# intel Technical Advisory

TA-730-1

## Intel® Server Board SE7520BD2V boxboards may contain an incorrect IO Shield

Figure 1: Correct I/O shield for the SE7520BDV boxboard.

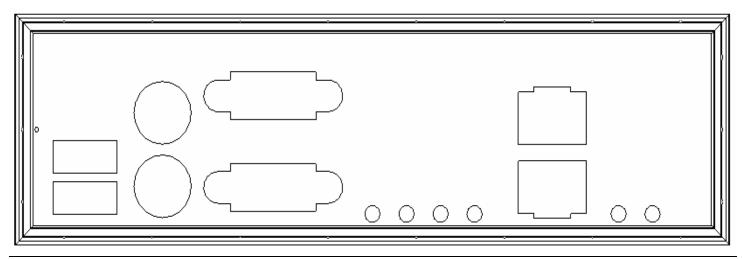
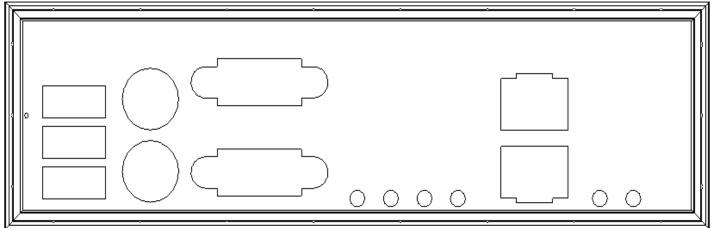
The Intel® SE7520BD2V Server Board boxboard was manufactured with the wrong I/O Shield. The correct I/O shield requires two holes for external USB connectors. However, initial shipments listed in **products affected** section above may contain an I/O shield with three external USB holes. You can determine if your boxboards contain the correct I/O by referring to **Figure 1**. **Figure 2a**, **b** represent the incorrect 3-holed USB shields. Without the correct I/O shield your selected chassis may fail to pass EMI validation testing.

During Manufacturing the factory incorrectly placed the Intel® Server Board SE7520BD2SCSI I/O shield in the SE7520BDV boxboard.

Please contact Intel Customer Support to obtain a replacement I/O shield for the SE7520BD2V boxboards and reference TA 730-1 or use your normal warranty support process to request replacement I/O shields for all SE7520BDV boxboards. You may also contact your Intel Sales Representative if you require more specific information about this issue.
